High-Strength Bolts for Bridges

Report No. FHWA-SA-91-031

Addendum

(date of Addendum: April 14, 1994)

2 - 13

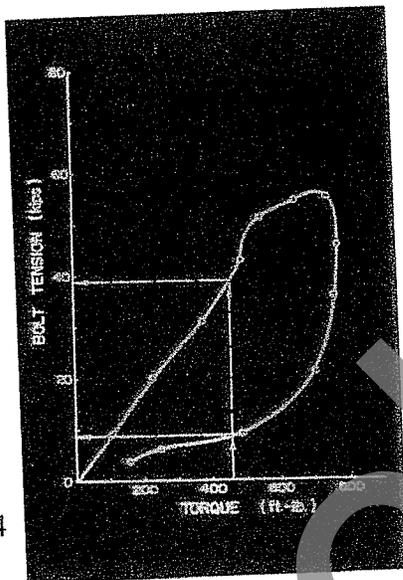
2-13

A325/M164
Type 1 & 2
Type 1 Galv.

Matching Nuts
A563/M291
C, C3, D, DH, DH3
DH

A194/M292
2, 2H
2H

7-2

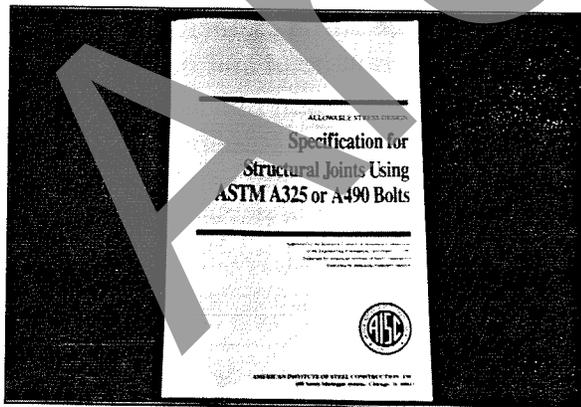
- 6-20 Change slide: "P = "turn test tension" from Table D4.1g.
- 7- 2 AASHTO Bridge code is now 15th edition, with Interim
7- 4 Specifications issued annually.

7 - 13

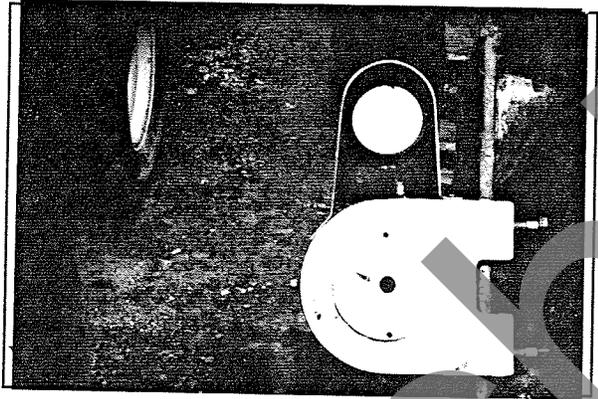
- 7- 8 Change slide: "whichever is less" to "whichever is greater".
- 7-13 Delete from text: "slip-critical".
- 7-14 Change text: "Table 10.17A" to "Table 11.5A".

9 - 5

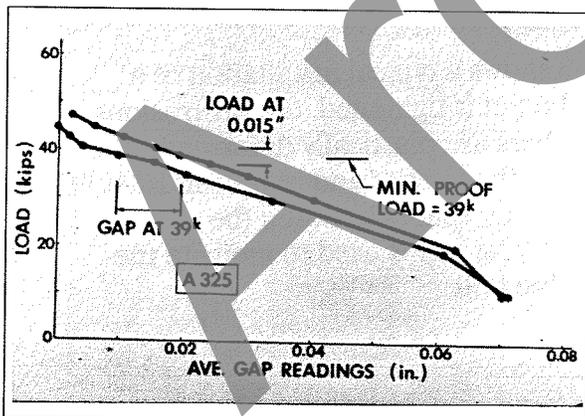
- 8- 3 Change text: "Table 10.17A" to "Table 11.5A".
- 8- 6 Change slide and text: "Table 10.17B" to "Table 11.5B".
- 9- 5 For bridge applications, the typical gap is 0.005 inches.
